TOWN OF ERIE
BOARD OF TRUSTEES MEETING
Meeting Date: August 14, 2018

SUBJECT: A Sketch Plan Review of Parkdale Sketch No. 2, single-family detached and duplex development.

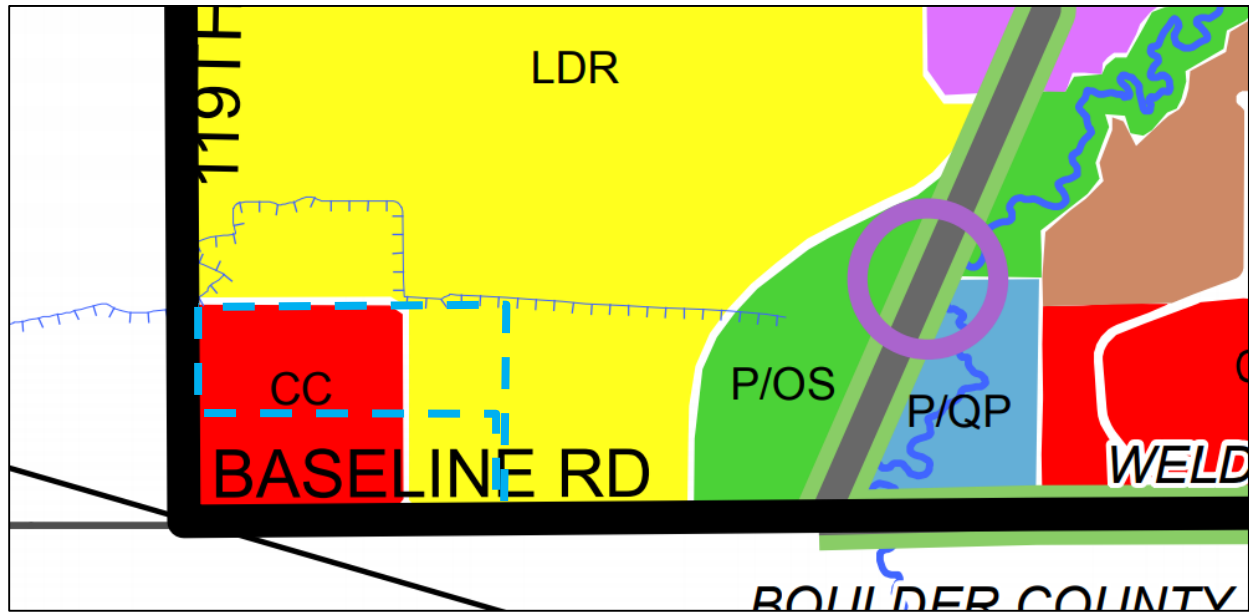
The Parkdale Sketch No. 2 application proposes to add a new area of development to the Parkdale subdivision. A collector road heading east from 119th Street provides access to the residential subdivision. This collector will also provide a connection for commercial development to the south. The sketch plan also incorporates several road stubs to adjacent properties that could develop in the future.

The development proposes two single-family detached lot types and one paired home lot type. Each home is proposed to be alley-loaded. Where homes do not have street frontage the applicant has provided 30-foot wide garden courts.
